From:	Lacy Garner
Sent:	Thursday, September 1, 2022 12:42 PM
То:	Aaron Fuller; Cassie Fuller
Cc:	Stephanie Morris; ryan@nfrrealty.com
Subject:	RE: Project 2021106455 Deskins Prelim Plat - Comment Matrix 3

Subject: RE: Project 2021106455 Deskins Prelim Plat - Comment Matrix 3

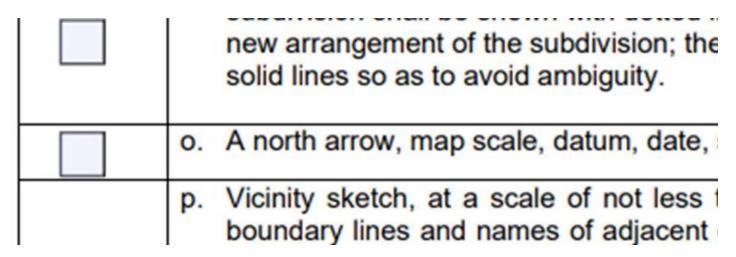
3.0 Directions to the site.

This is still not shown on the preliminary map, as required per the checklist.

Here is a snapshot of the checklist you are quoting:

As you can see there is no specific language saying directions to the site need to be specifically written on the plans with turning movements spelled out and done with language. Directions to the site can be shown in map form which is typically done in the vicinity map. What I'm saying is that your request is not valid to add this information in language format so we should ignore that comment. This also goes for the landscape items that are not applicable along with the advisory building permit items Torren talks about. We appreciate all the discussion but its not really applicable at this point and it can be ignored in the land use process. Over half the comments are not even valid. At an absolute minimum a new matrix should be developed which specifically identifies which checklist items were left out and which codes were broken.
